Unbalance

Rev. 3

MICHAEL PAUL

Figure 145-22—PSE PI unbalance specification and system resistance unbalance

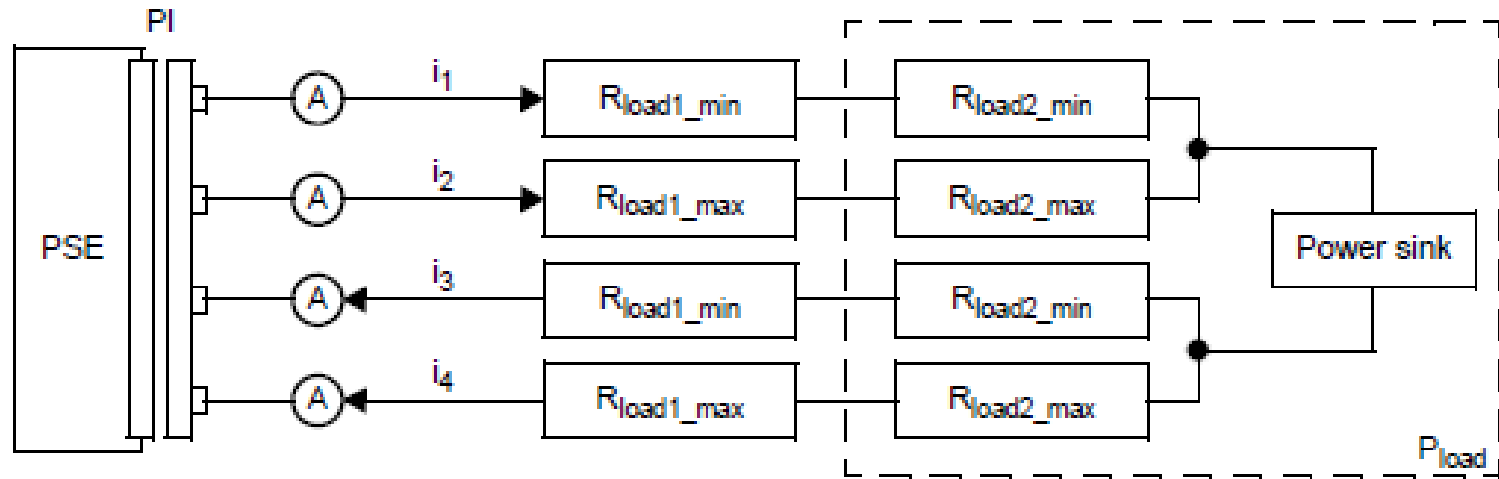
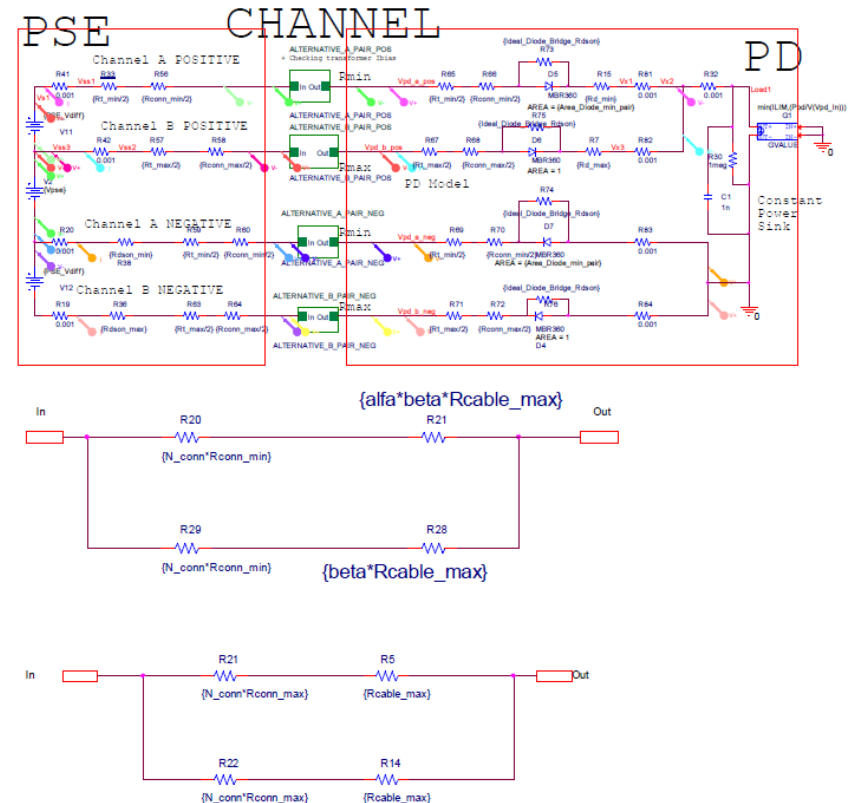
- ▶ Draft 3.1 $I_{\text{Unbalance-2p}}$ was changed to 560mA to provide margin.
 - Now, using the PSE test from table 145-18, $R_{\text{PSE_alpha}}$ can be changed to 2.67 and pass the compliance test
 - That is the PSE can be more unbalanced and pass the hardware compliance test

- ▶ Plugging $R_{\text{PSE_alpha}} = 2.67$ back into the System Unbalance model gives $I_{\text{Unbalance-2p,max}} = 571\text{mA}$
- ▶ This PSE passes the compliance test but may fail to interoperate

- ▶ We need two unbalance numbers
 - $I_{\text{Unbalance-2p}}$ for the hardware unbalance test (component unbalance contribution)
 - $I_{\text{Con-2p-unb}}$ for the system at runtime (software-controlled current threshold)

- The hardware test limit must be less than the runtime unbalance limit to ensure margin
- ▶ $I_{\text{Unbalance-2p}}$ is the hardware unbalance test
 - PSEs and PDs should not exceed $I_{\text{Unbalance-2p}}$ when connected to the test load/source

- $I_{\text{Unbalance-2p}}$ should use the $I_{\text{Con-2p-unb}}$ numbers from Draft 3.0
 - Draft 3.0 $I_{\text{Con-2p-unb}}$ numbers define system performance given PSE, cable and PD unbalance allocations

- ▶ $I_{\text{Con-2p-unb}}$ is the runtime test
 - A PSE should not remove power from a PD until at least $I_{\text{Con-2p-unb}}$ is drawn from a pairset

- $I_{\text{Con-2p-unb}}$ should maintain the numbers specified in Draft 3.1
